Determination 2024/014

Compliance of a stormwater tank near a property boundary with Building Code clauses concerning fire affecting other areas

Future lot 26, Border Road, Henderson, Auckland

Figure 1: Site plan (not to scale)

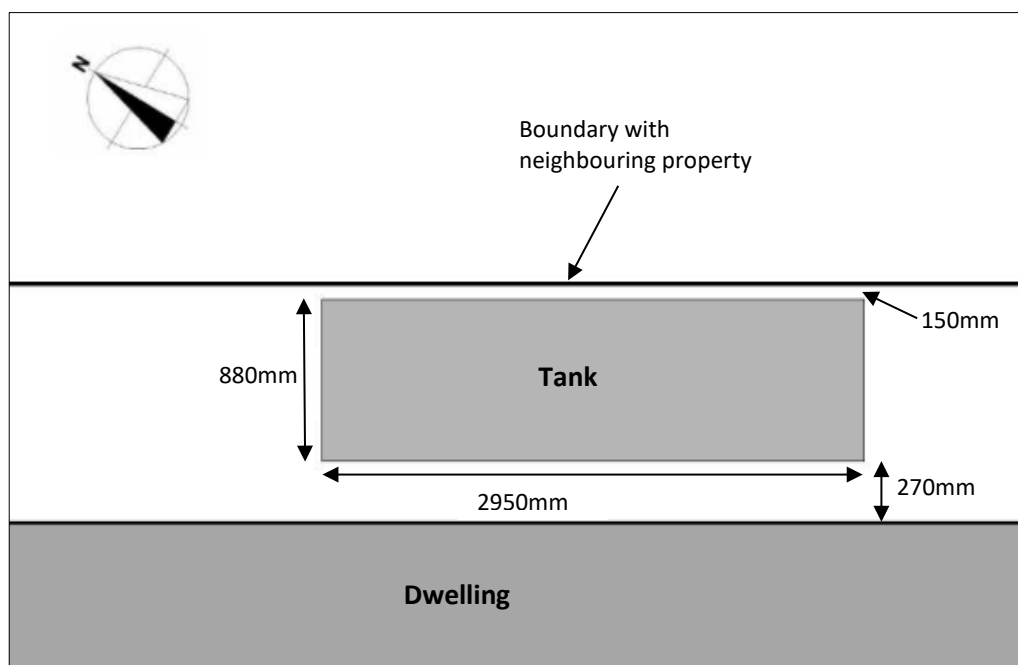
Please justify compliance with NZ Building Code clauses C3.6 and 3.7. The storm water detention tank is shown against the boundary on sheet 101. Your nominated means of compliance requires these to be fire rated if they are within 1 m of the boundary. Please provide calculations or evidence showing the ignition and heat output requirements of the building code will be [met] in the current location.

... we have had an independent fire engineer review the installation of plastic tanks on the boundary. [They] concluded that the ignition data provided to [them] suggested the tanks [they] reviewed would not meet [clauses] C3.6 and C3.7. Could you please provide the tank testing information [showing] the tanks, if installed within 1m of the boundary would meet the requirements of building code clauses 3.6 and 3.7.

- 4.18. The term ‘relevant boundary’ is defined in Clause A2 *Interpretation*.¹⁰ In this case the relevant boundary is the boundary of the property as marked on Figure 1, which is 150mm from the tank.
- 4.19. Clause C3.6 refers to “in the event of fire in the building”. In this case, in my view it is very unlikely a fire could occur “in” the tank. It is difficult to see how a fire could start inside the tank, given that the plastic tank would contain water and air. This conclusion is consistent with the functional requirement in clause C3.3 that there be a low probability of fire spread to other property.
- 4.20. Therefore, clause C3.6 is not applicable to the tank, and it is not necessary to consider the received radiation at the relevant boundary and 1m beyond.

4.25. The tank is located 150mm from the relevant boundary, being the boundary of the property with the neighbouring property. This is closer than 1m.
